MEMORANDUM

To: Development Review Board
From: Mary O'Neil, AICP, Principal Planner
Date: September 15, 2020
RE: ZP20-0717CA/MA, ZP20-0718CA, ZP20-0719CA, ZP20-0720CA; 273 Pearl St., 11, 15 and 21 Hungerford Terrace

Request: Planned Unit Development to include demolition of a single family home at 15 Hungerford Terrace and a garage at 11 Hungerford Terrace; demolish south porch and move garage at 21 Hungerford Terrace; construct 12 unit residential building. Net new units = 11 (if earlier duplex approvals are relinquished.) Site changes, including retaining walls, stormwater infrastructure. Parking changes with 17 space parking waiver request (42% of required residential parking.)

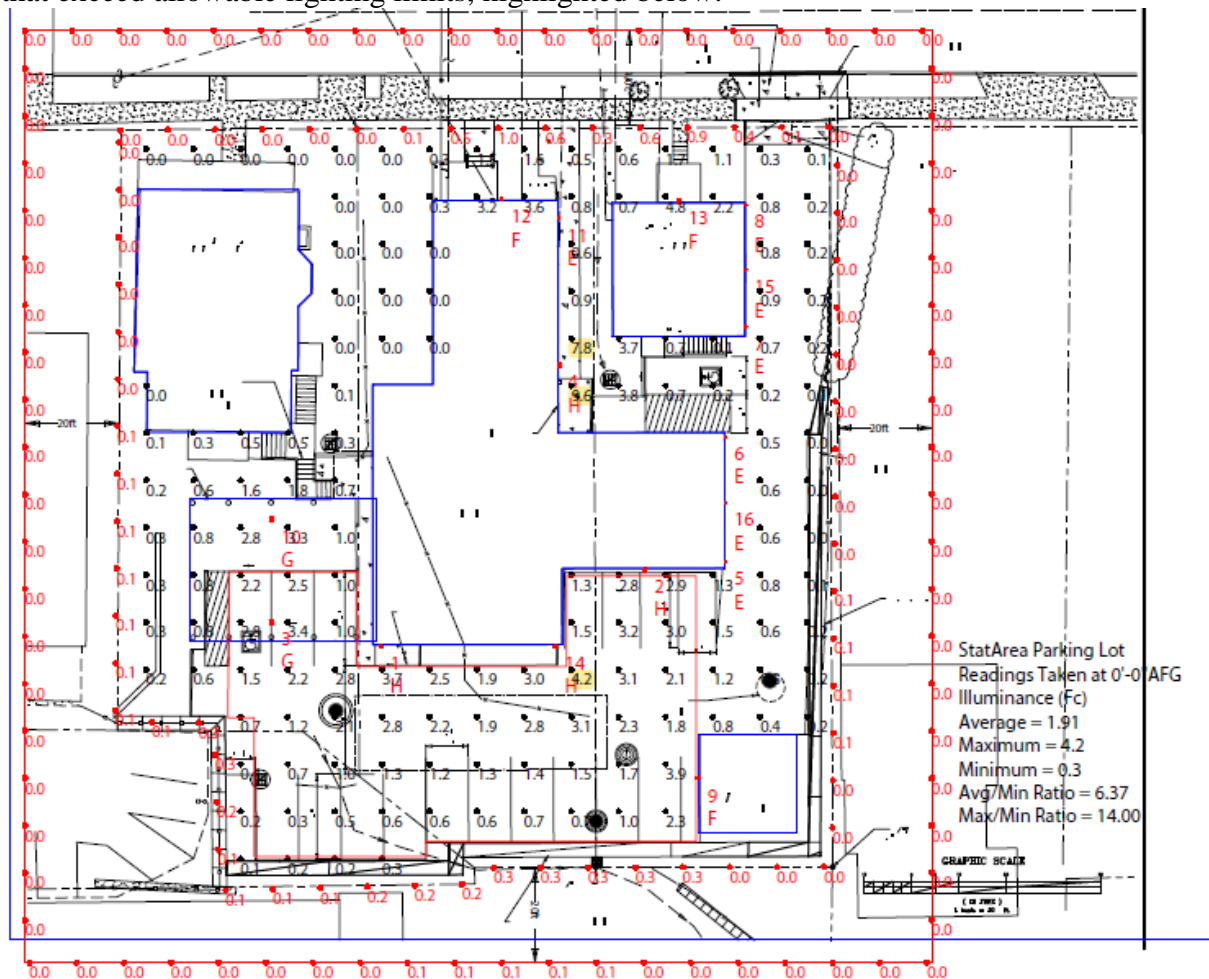
Retaining walls greater than 5 feet tall shall incorporate textured surfaces, terracing, and/or vegetation to avoid long monotonous unarticulated expanses and to minimize adverse visual impacts to neighboring properties. As with fences, retaining wall styles, materials, and dimensions shall be compatible with the context of the neighborhood and use of the property.

Civil plans C2.2 and C4.2 and Plan A8 define the gravity wall as terraced with plantings.

Heights vary from 2-12’. As the involved properties all sit on the cusp of the Burlington Ravine and have consistently struggled with the changing grade inherent to their site, this is the context of the neighborhood. Review of retaining walls greater than 3’ in height is the responsibility of the City Engineer. **Affirmative finding as conditioned.**
